File Code: 2810
Date: July 2, 2021

On June 9, 2021, Nicole Malandri, Lands and Mineral Staff, conducted an inspection of the Lombard #4 and #5 sites. At that time, the Lombard #5 adit had not been opened. The following items were discussed:

BAT GRATE ALTERNATIVES

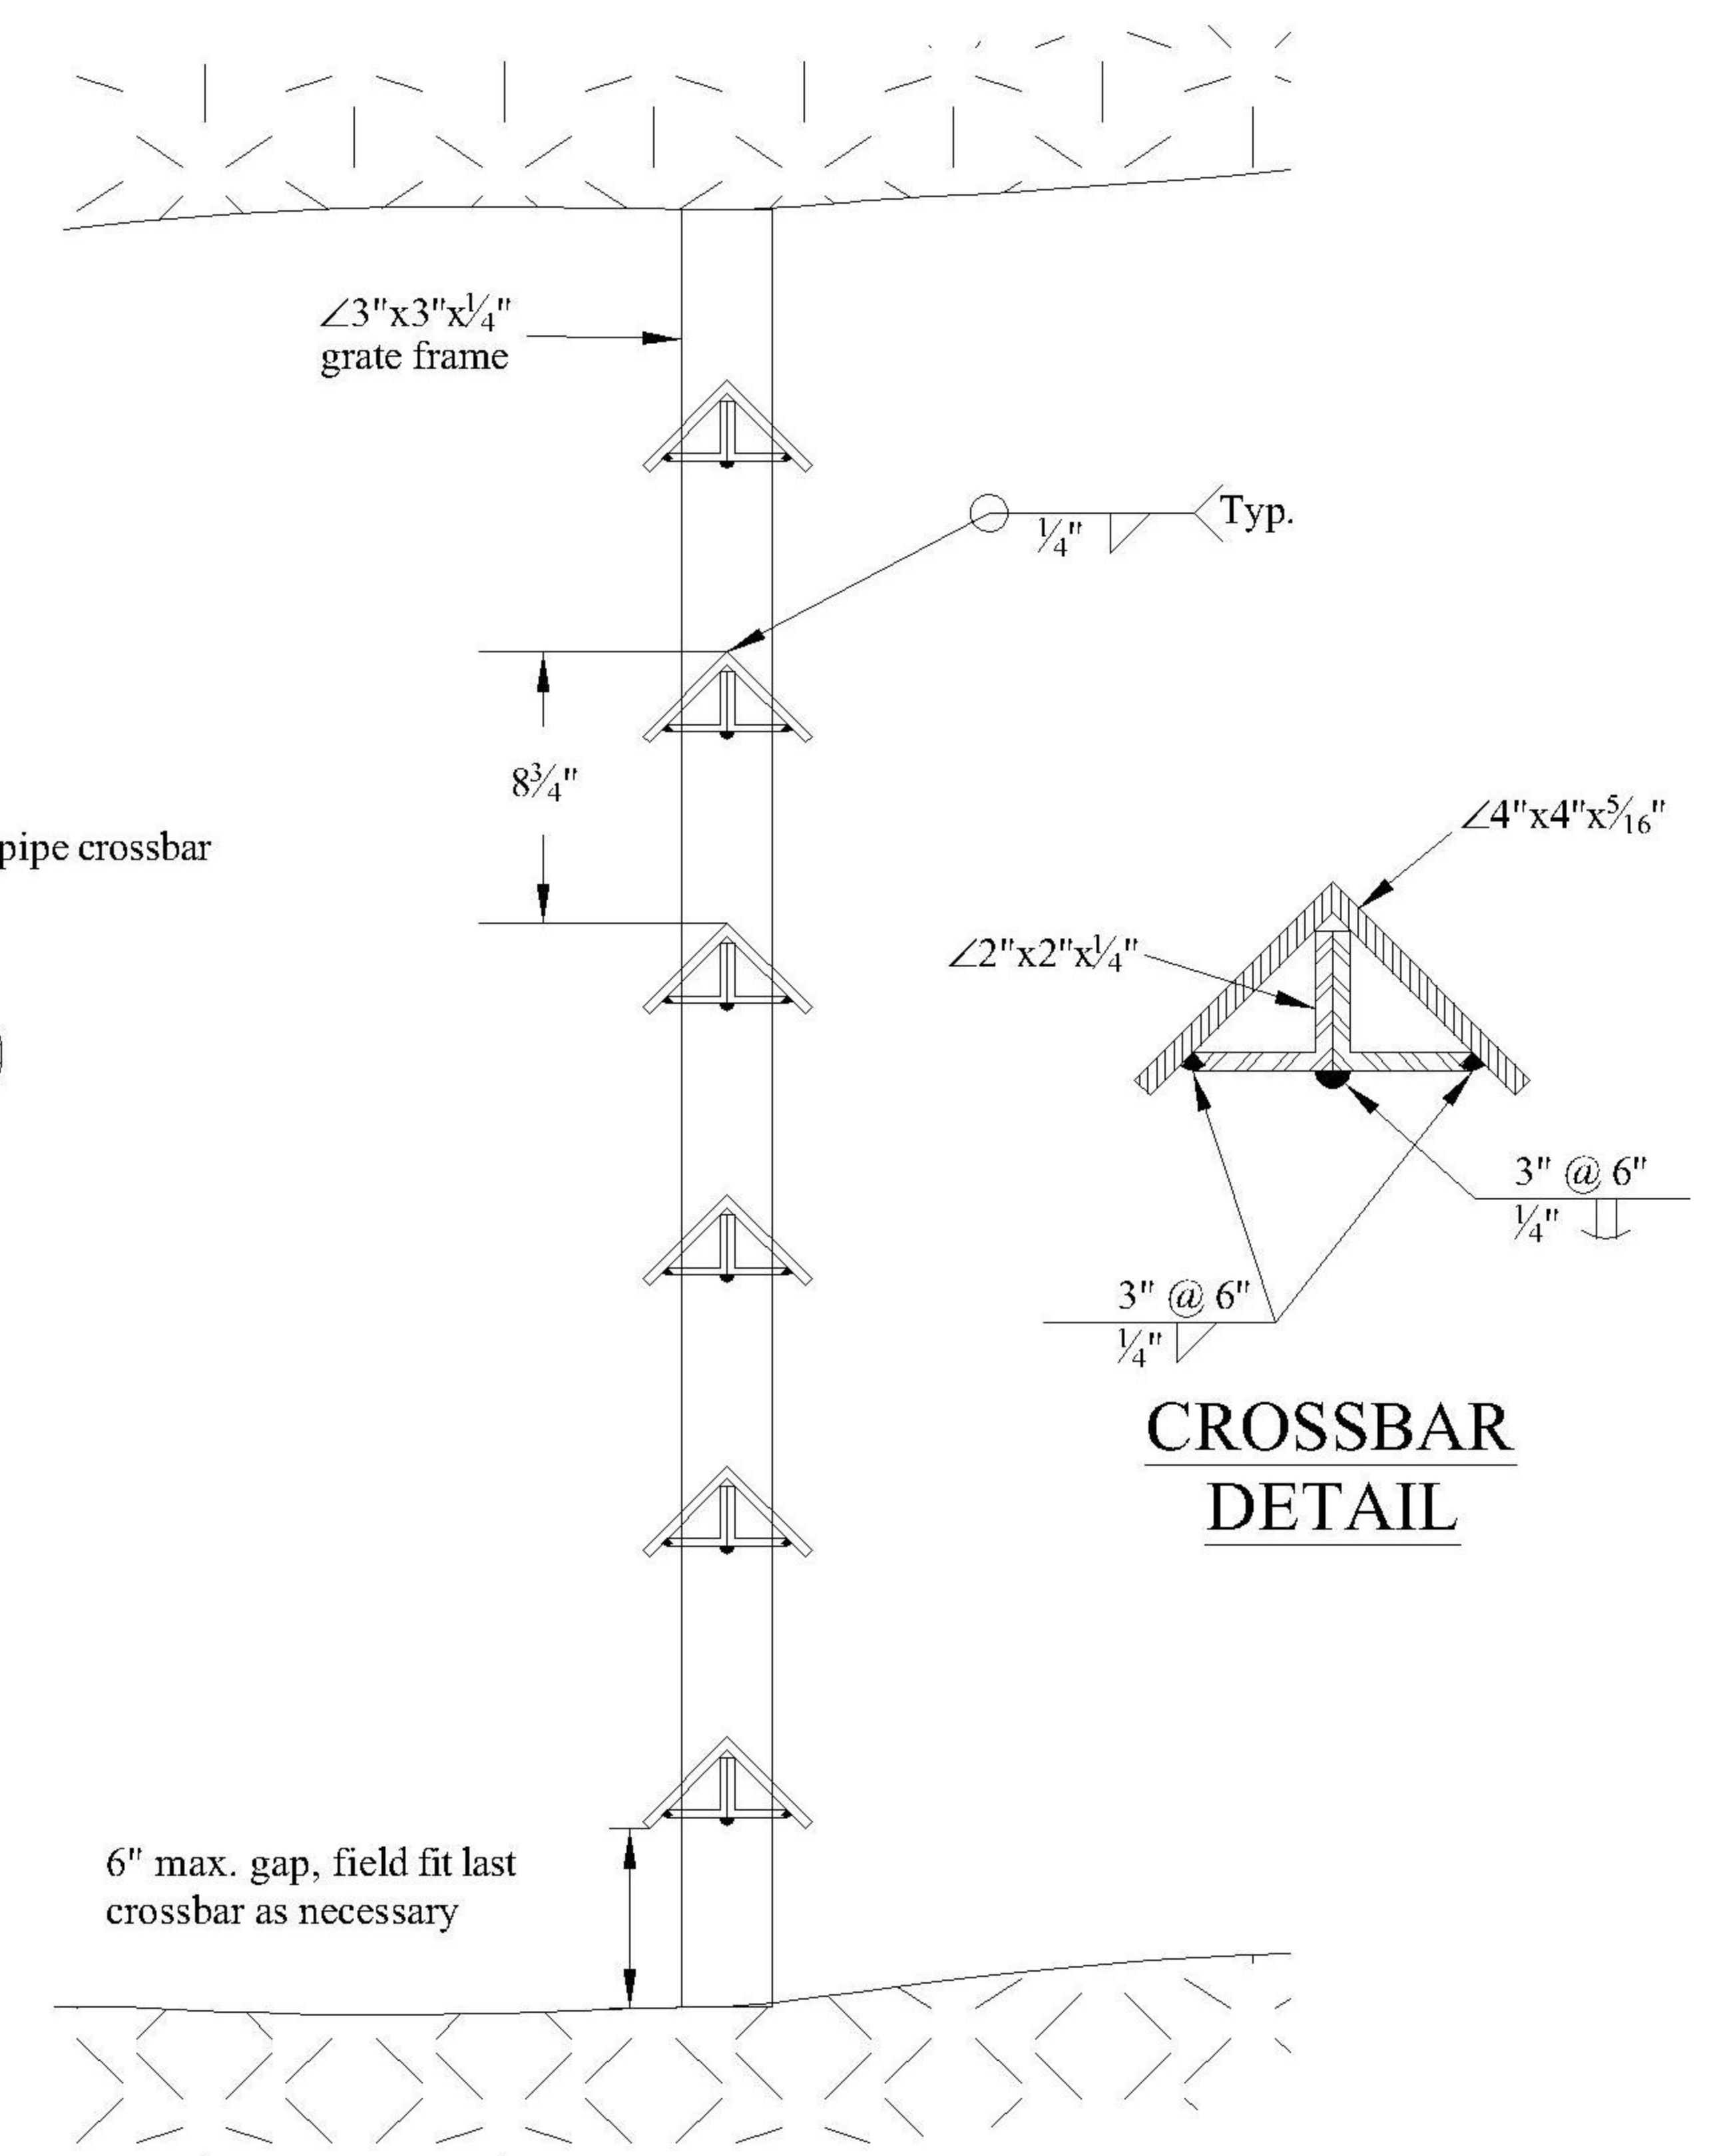
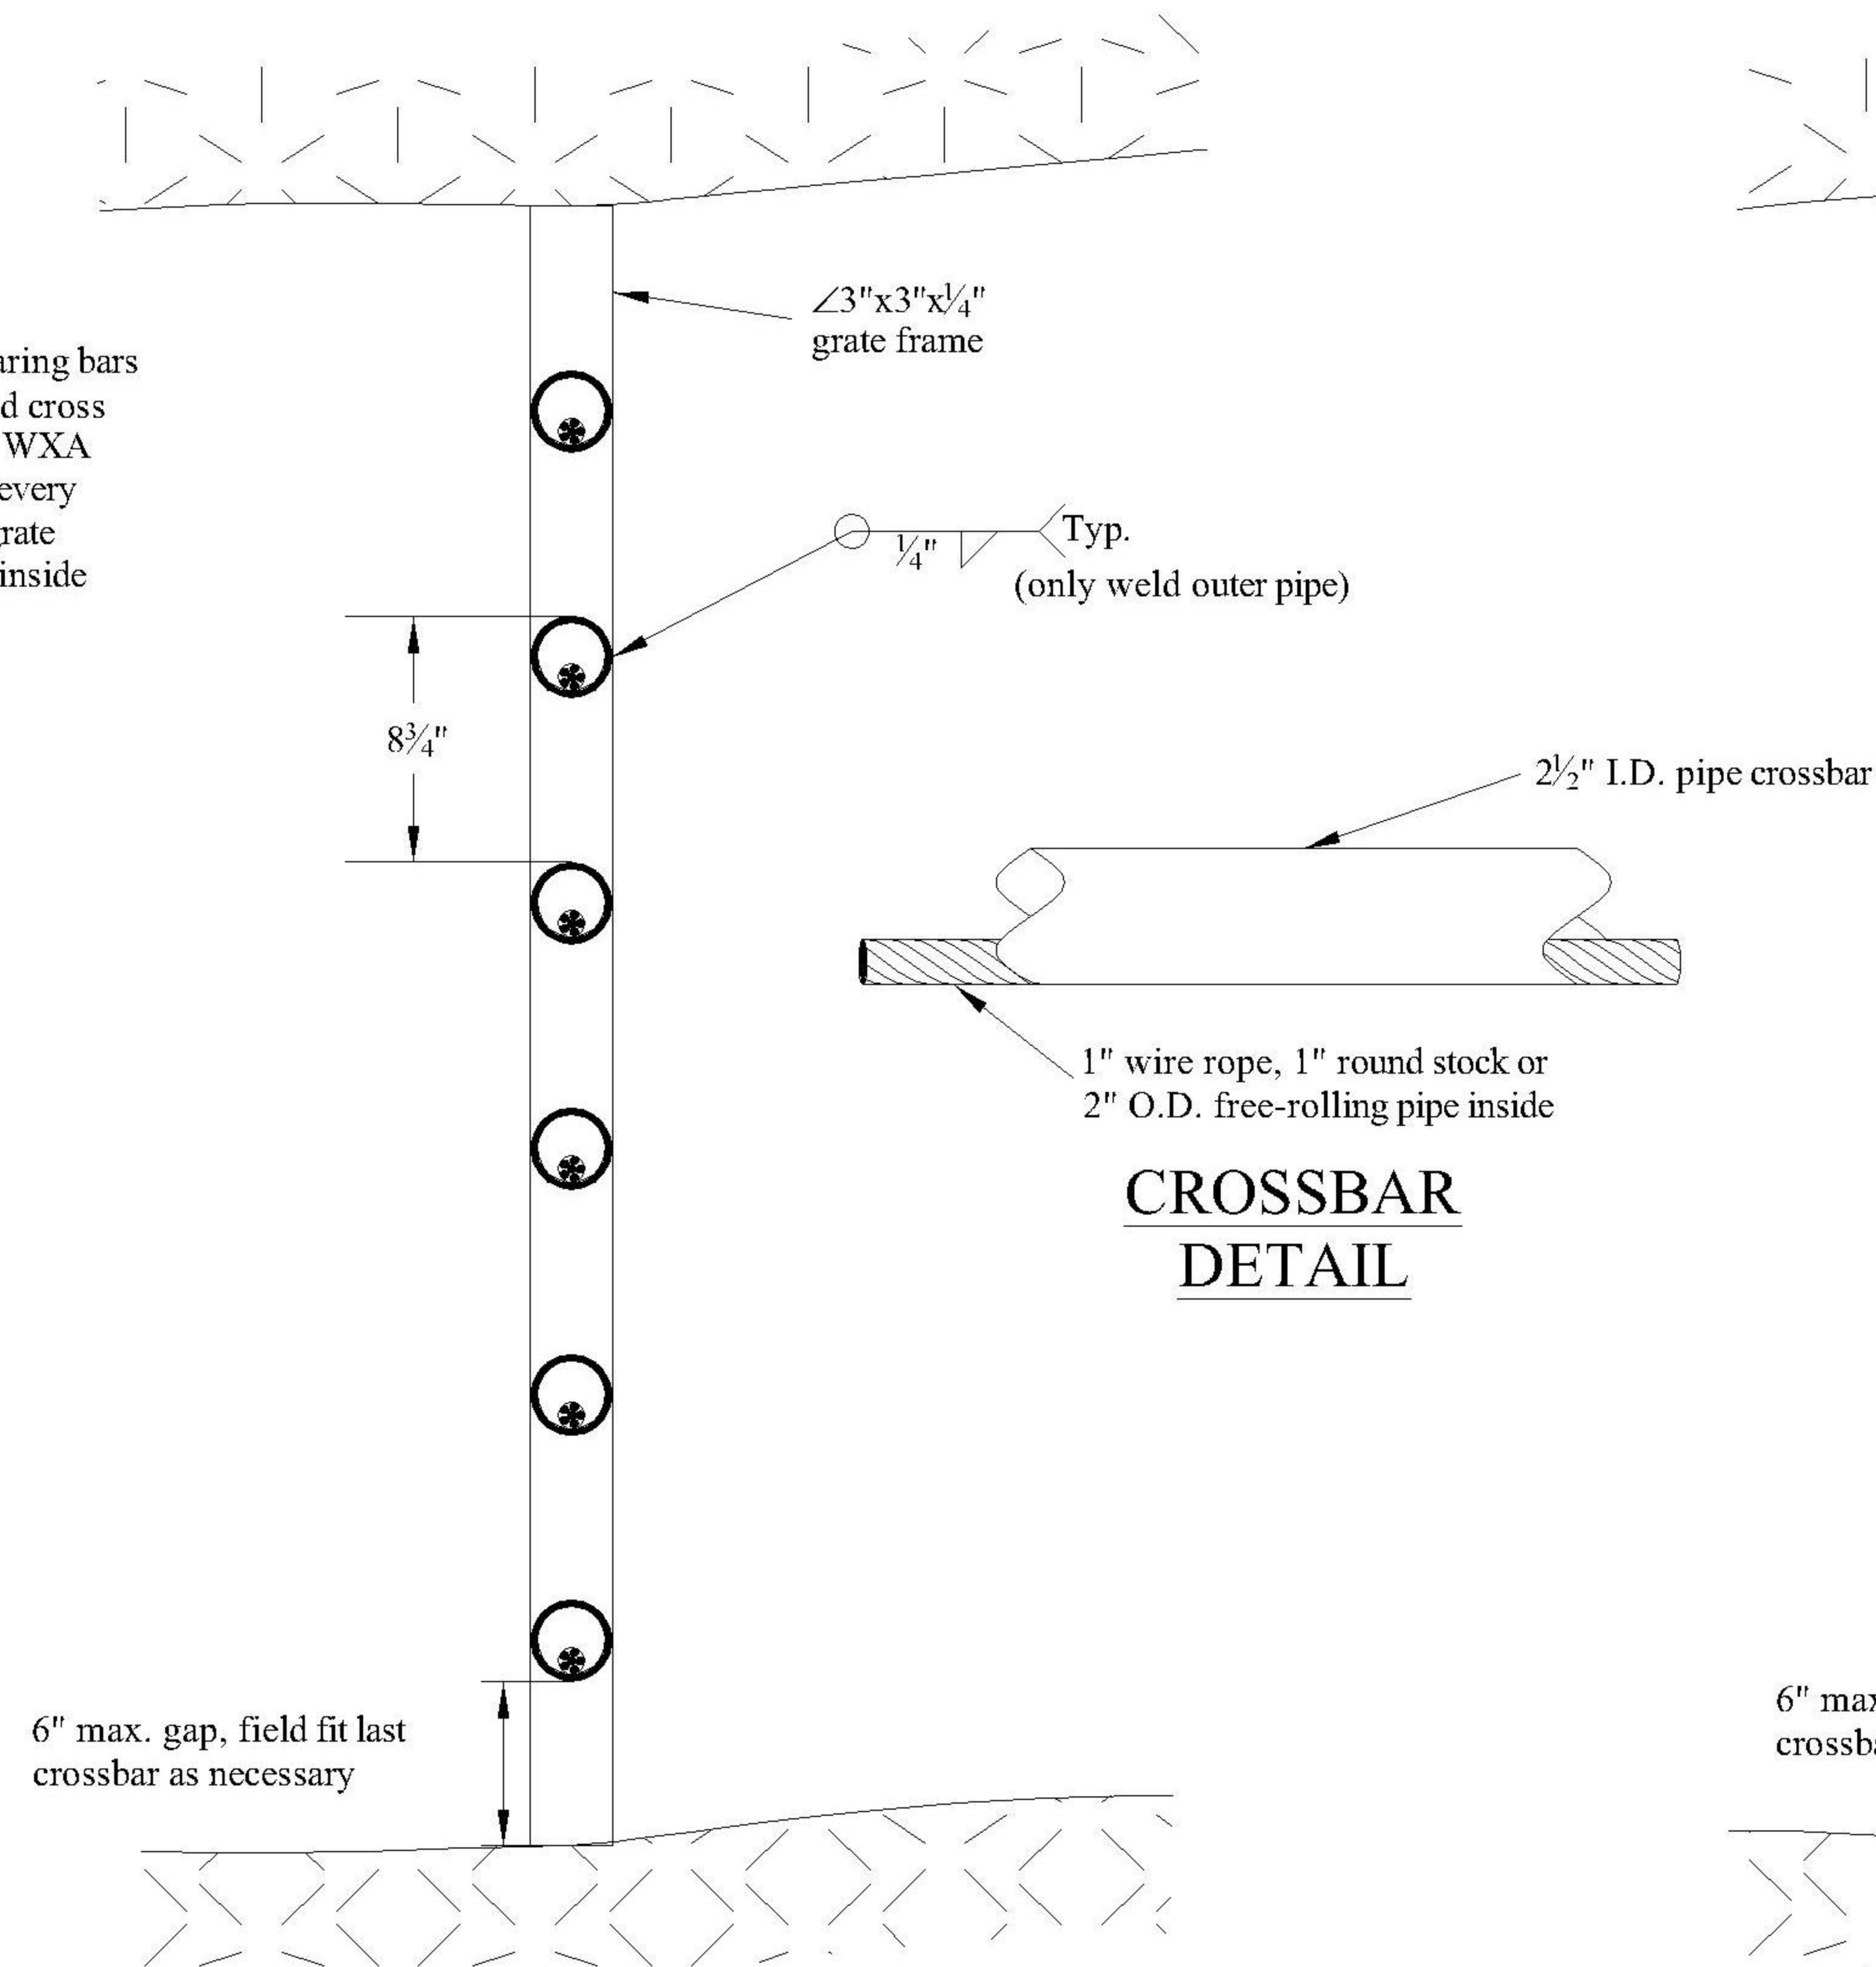
- There was a small rock fall at the Lombard #4 adit opening. When the adit is reopened a bat gate will need to be installed to replace the current adit closure. A sample design has been provided.
- All human waste must be transported off NFS land and disposed of in accordance with state and local regulations.
- The operator will use spill pads when pouring fuel or other petroleum products into tanks or other containers, to contain any spillage before it reaches the soil or water.
